## Review of Tube R2C5 in Steam

Generator 24  
Phase settings between 1997 and 2000

## Review of Indian Point

**Figure 4** Plot of 1997 scan of tube 2-72 of steam generator 24 made at 400 kHz made with midrange plus-point.

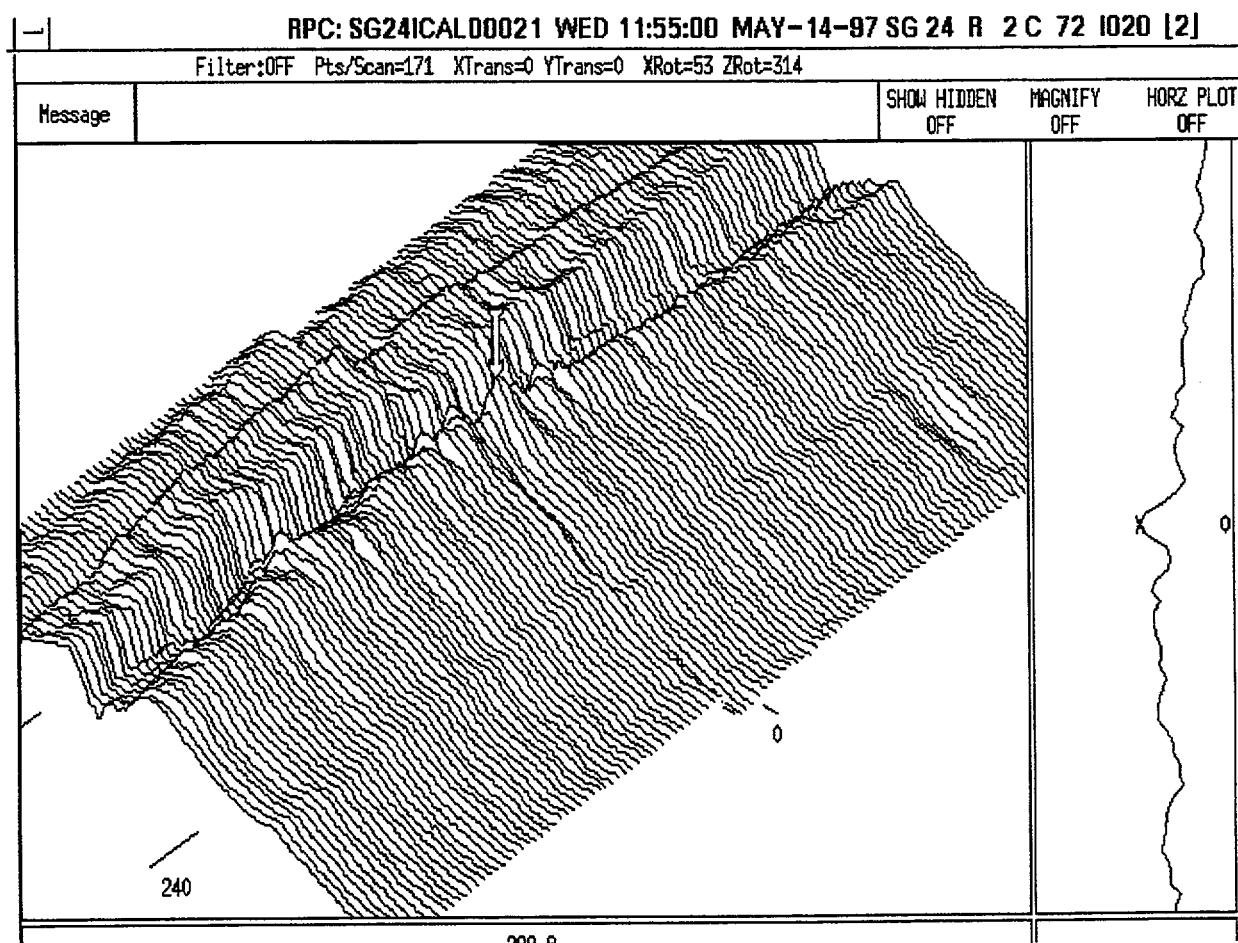
In Figure 4 we show a scan of the midrange plus-point, using the present phase setting. The indication is barely visible, and was not called in 1997. In figure 5 we show a scan of the same tube using the small, high-frequency plus-point, that has been calibrated in a similar manner. The improvement in the signal-to-noise ratio makes this defect very easy to detect. The reduction in noise will also allow more accurate profiling of the cracks. The signal-to-noise improvement is partially the result of the probe being made smaller also. The new probe has less noise at the 300 and 400 kHz frequencies than the old mid-range probe has.

**Figure 1** Profile of the defect in tube R2 C69 of steam generator 24 as measured with the high-frequency plus-point at 1000 kHz and 800 kHz.

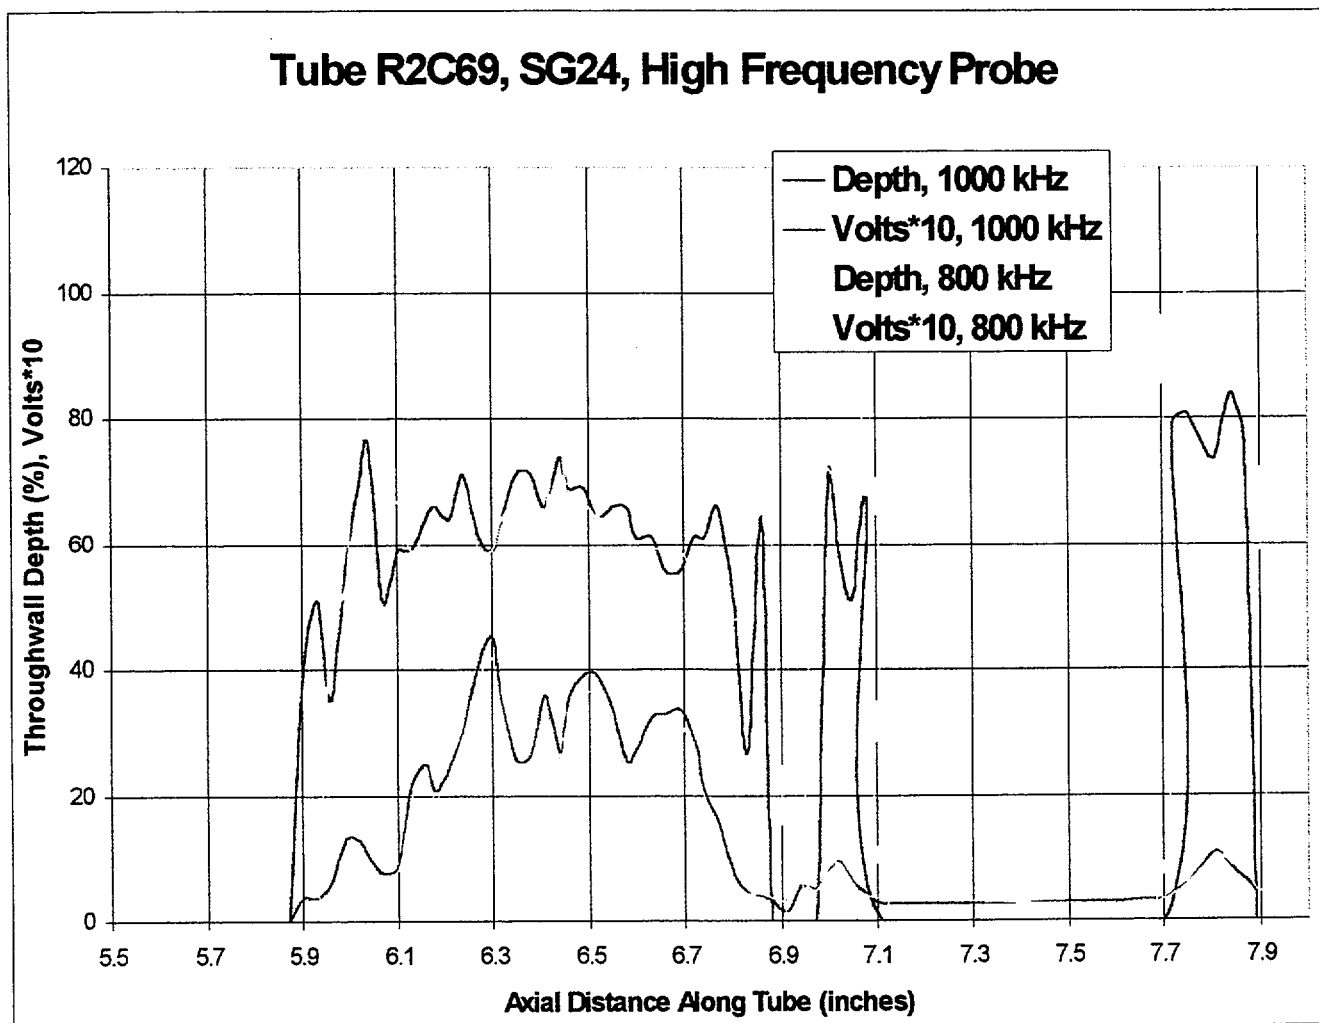
I believe that defect with a maximum voltage of 1.0 volt or higher should be detected. Once this defect has been detected, it can be tracked through the noise as small as about 0.2 to 0.4 volts. However, there will be considerable error in the measurement of the depth at voltages below 1 volt. In Figure 1 we show the profile of the defect in tube R2 C69 of steam generator 24. The tube has been profiled with the high-frequency probe at 1000 kHz and 800 kHz. The depth and the voltage (times 10 to fit on the scale) at each frequency is given. The voltage measured for the 1000 kHz is slightly higher than that for the 800 kHz. The signal-to-noise for the 800 kHz may be slightly better, since od indications are rotated more horizontal, while at 1000 kHz the rotation

has gone slightly past horizontal. The depth measured at the two frequencies is about the same. However, this tube had very little noise even with the old mid-range plus-point probe. The indication located at about 7.8-inches has a maximum value slightly greater than a volt, and the agreement between the two frequencies is not as good in this region. This defect at 7.8-inches was not included in the profile mid-frequency plus-point results furnished by the utility.

**Figure 2** Profile of the defect in tube R2C71 in steam generator 24 as measured with the high-frequency plus-point at 1000 kHz and 800 kHz.

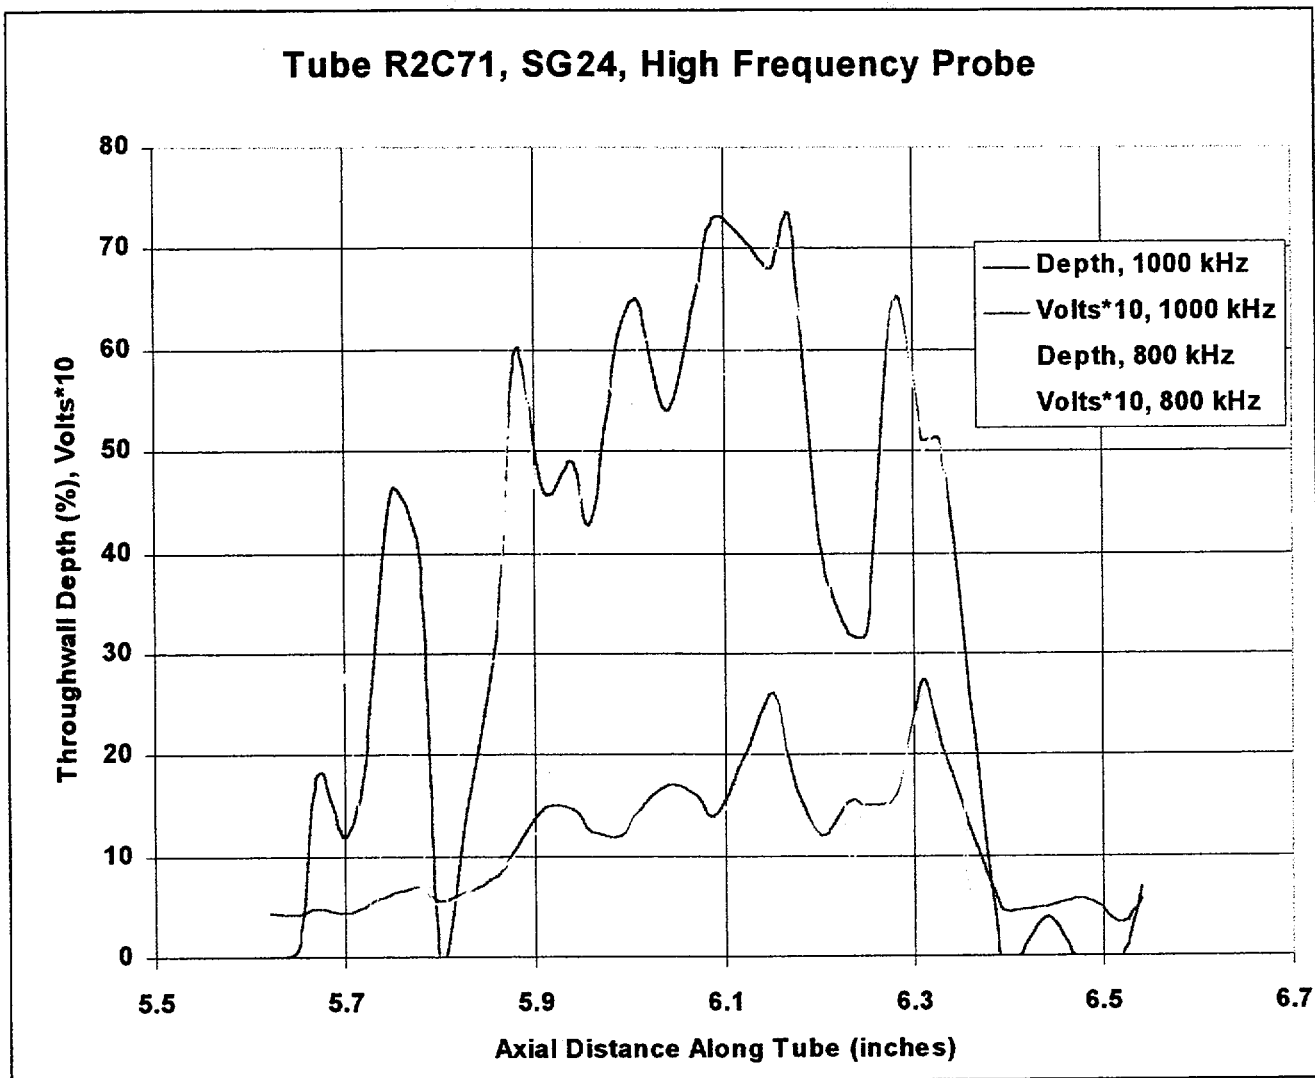
In Figure 2 we show the profile of tube R2C71 of steam generator 24. This tube had a small leakage at 2841 psig. The pressure could not be increased past 4500 psig due to the lack of capacity of the pump. Note that this tube was missed in the earlier inspection with the mid-range

probe. The depth profiles at 1000 kHz and 800 kHz do not match each other as well, which is due mostly to the low voltages that are present. This tube has about the same depth measurements as tube R2 C69 in Figure 1, but the voltage values are only about half as large. Note the depth measurements do not agree well where the magnitude of the voltage is low. When the voltage falls below 0.5 volts, the depth measurement becomes quite inaccurate.

**Figure 3** Profile of the defect in tube R2 C74 of steam generator 24 as measured with the high-frequency plus-point probe at 1000 kHz and 800 kHz.

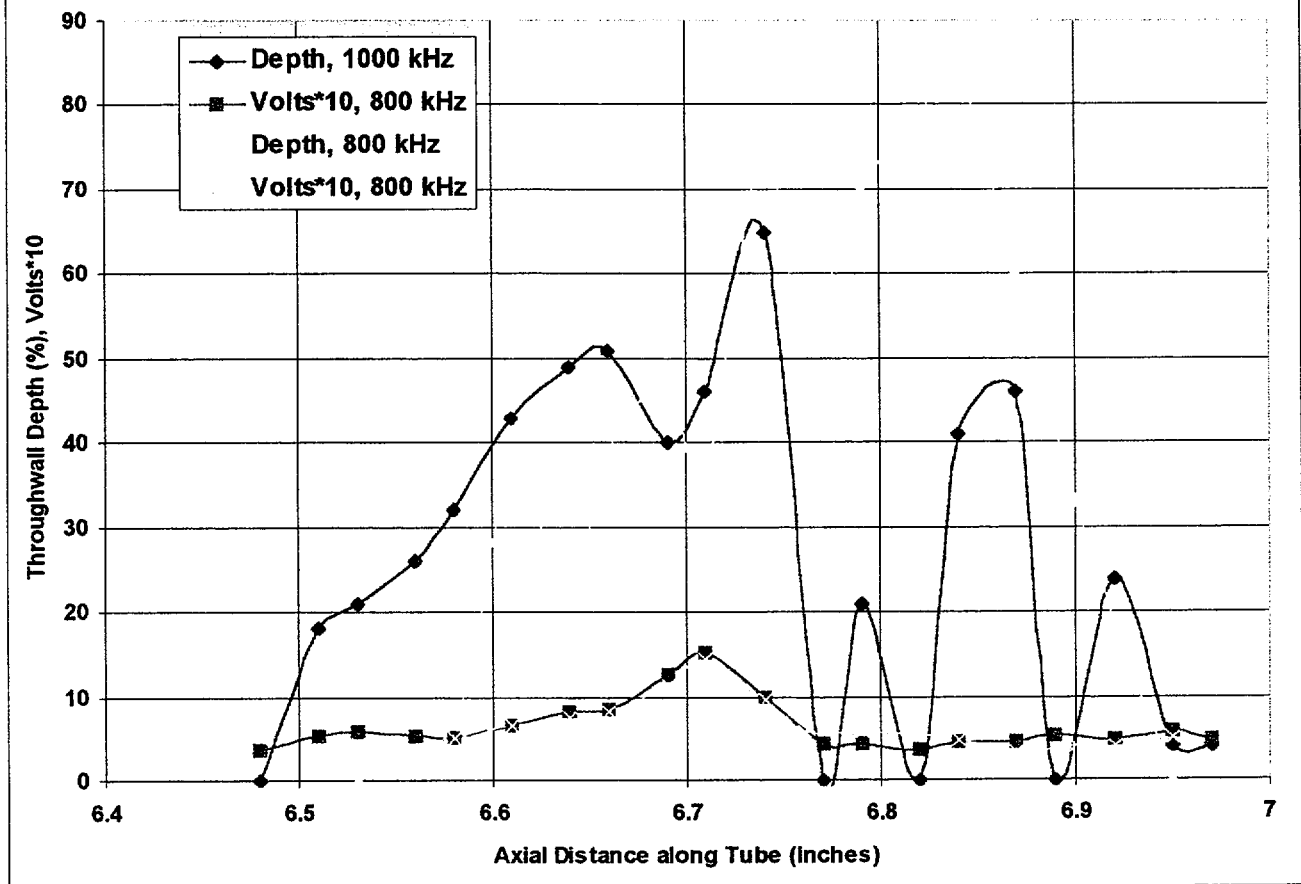
The profile plot for tube 2-74 is shown in Figure 3. The defect has a maximum voltage of only about 1.5 volts. There is very poor agreement in the depth measurement at the edges of the defect where the voltage is small. There was some noise that increased as frequency decreased at the 6.8 to 6.9-inch region of the tube. This tube has a portion of the defect that measures in the 40% to 50 % deep range, between 6.6 and 6.7-inches. This shows some of the probe's ability to measure and detect defects in this depth range. Unfortunately, this tube leaked at 5500 psig.

**Figure 4** Profile of the defect in tube R2 C4 of steam generator 24 as measured with the high-frequency plus-point at 1000 kHz, 800 kHz and 300 kHz.

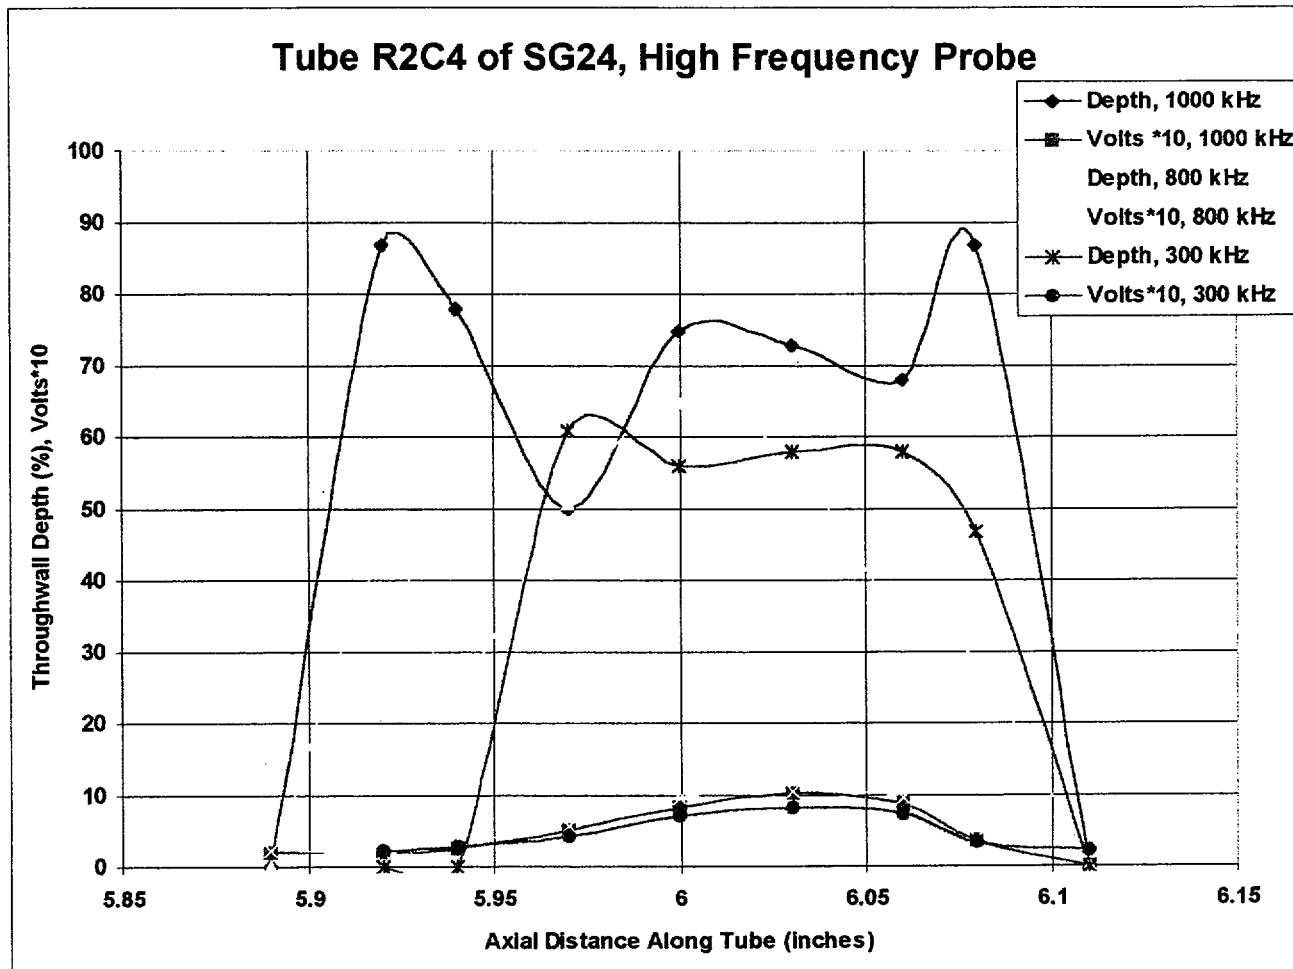
In Figure 4 we show the profile of tube R2 C4 of steam generator 24. This tube was profiled with the high-frequency probe at 1000 kHz, 800 kHz and 300 kHz. The maximum voltage measured for this tube was only slightly greater than a volt, which probably has caused the wide variation in depth measurements at the different frequency. This defect is the shortest of all of the defects that we have looked at thus far. This tube did not leak at 5500 psig.

**Figure 5** Profile of the defect in tube R2 C72 of steam generator 24 as measured with the high-frequency plus-point at 1000 kHz and 800 kHz.

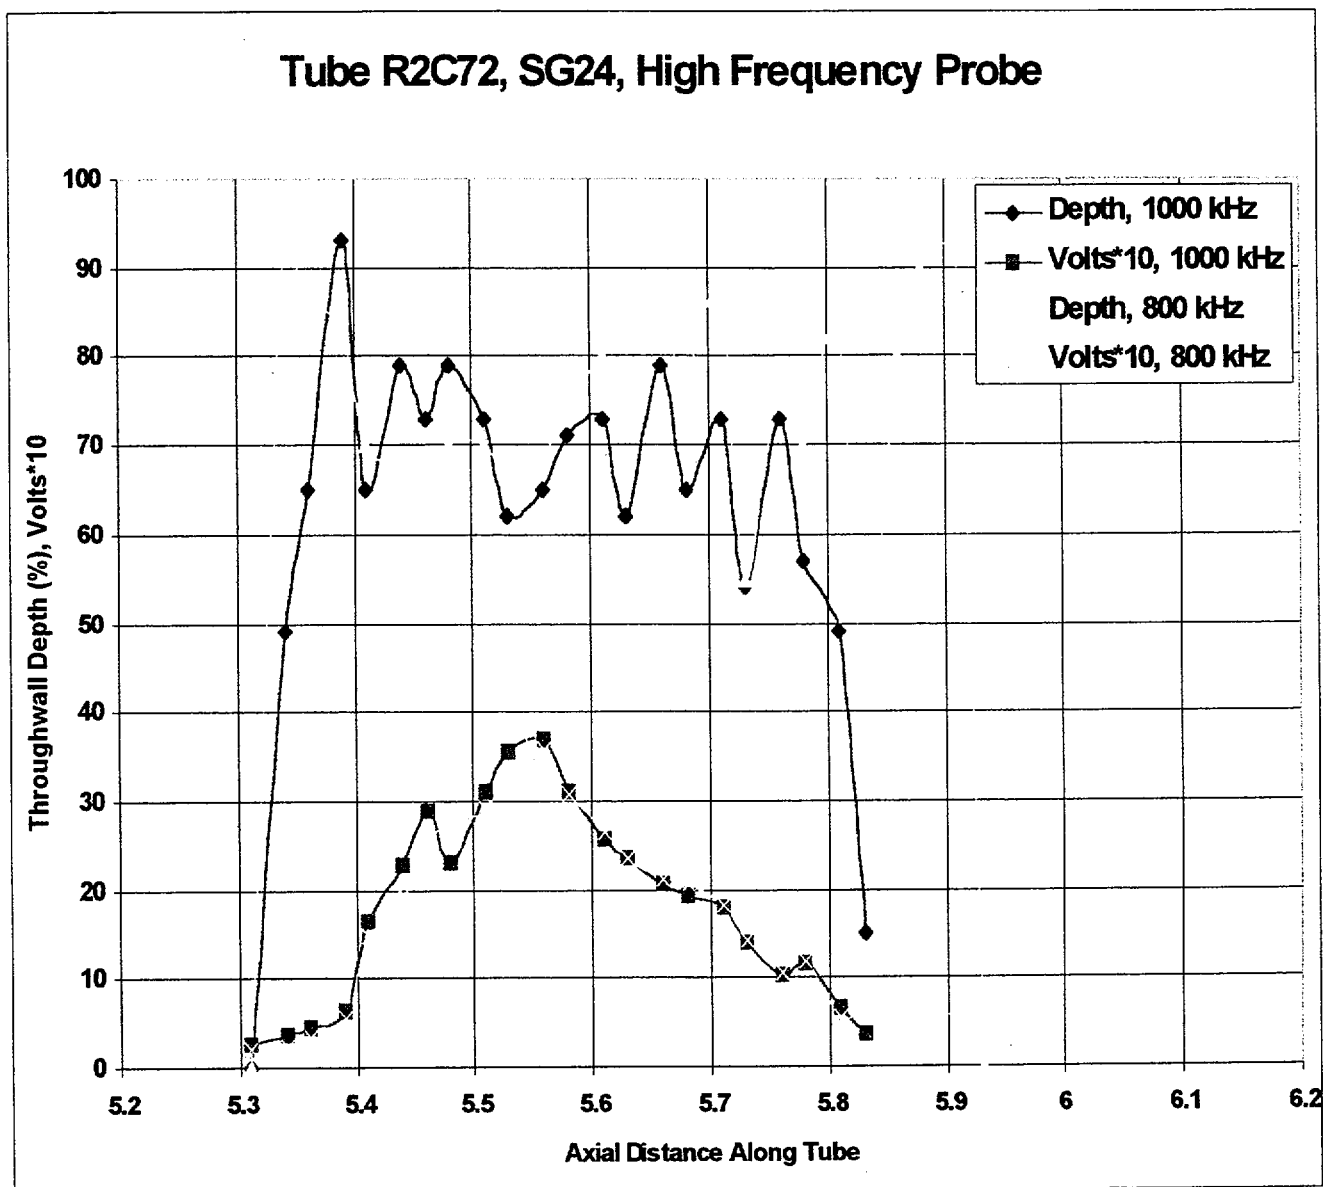
In Figure 5 we show the profile of tube R2 C72 in steam generator 24. This tube has a relatively high voltage and the phase measurements show a deep depth. However, this tube did not leak at the 5500 psig pressure test, although tubes with more shallow defect measurements and lower voltages did leak. As with the previous tubes, the depth measurements made at higher-voltage agree but not for the lower voltage measurements. There appeared to be od deposits that were influencing the signal at the 5.8 to 5.9-inch location.

Figure 1 C-scan with 1997 phase setting.

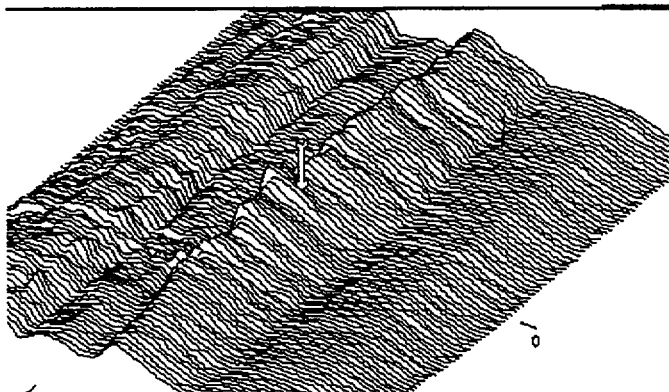
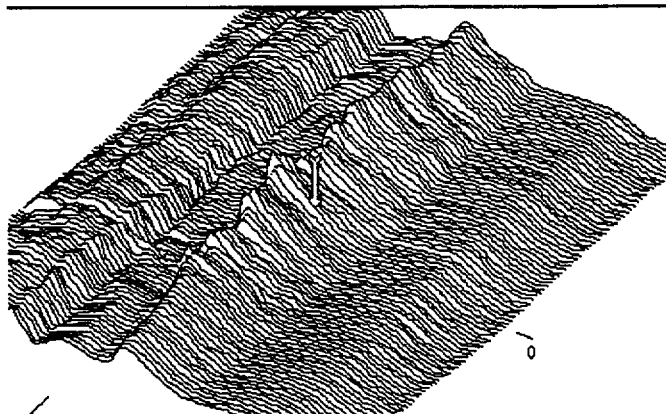
In 1997 the phase rotation for the eddy-current calibration was set too low, resulting in a decrease in the vertical signal that the analyst uses for screening for defects. In Figure 1 we show the c-scan plot with the phase set too low. In Figure 2 we show the phase setting that is being used for the current inspection. The indication, which is riding on a noise ridge, is easier to see.

With proper training the analyst would be more likely to discover the indication with this phase setting. In Figure 3 we show the Lissajous of the indication that the arrow is pointed to.

Figure 5 Noise signal that runs the length of the u-bend.

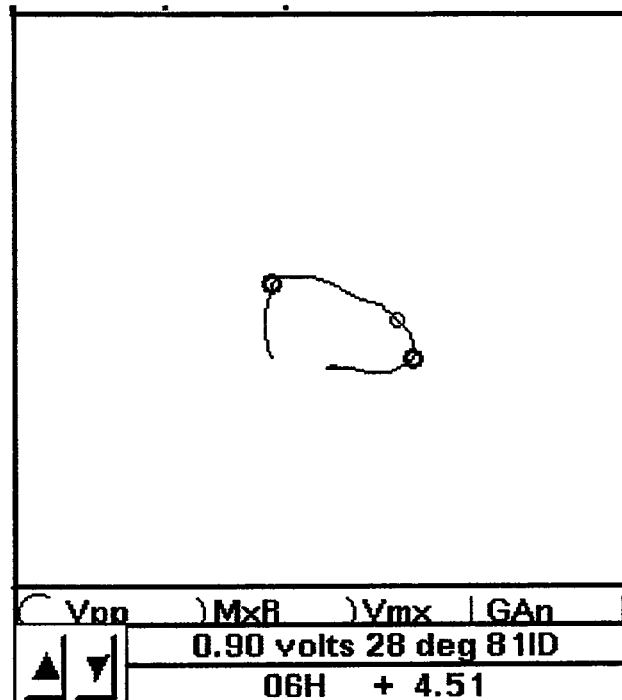
The defect signal sits on a noise ridge that runs the length of the tube. This noise ridge is about 1-volt in amplitude and measures as a deep id defect, on the order of 70 to 100% deep. This ridge makes both the detection and sizing of this defect more difficult. In Figure 5 we show the lissajous of the noise ridge. The signal-to-noise is slightly better for the 400 kHz frequency than the 300 kHz.

Figure 6 C-scan of the crack at 10 kHz

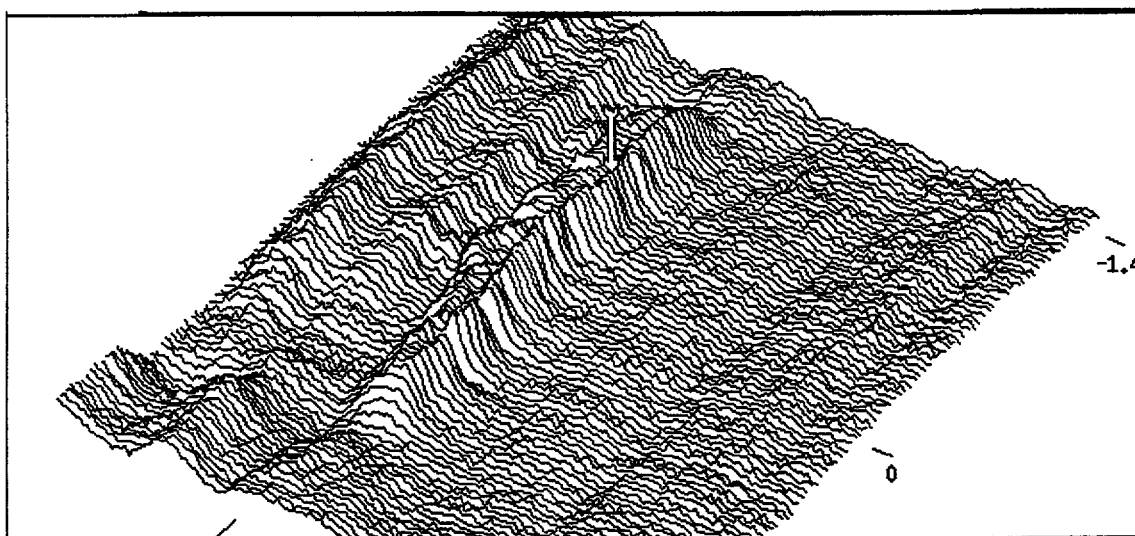
There is a signal on the 10 kHz channel that follows the defect. It is not known why the signal is visible at this frequency, although it may be due to a slight ferromagnetism of the crack. In Figure 6 we show the c-scan of the signal that has the same outlines as the crack. This scan also has signal-to-noise problems.
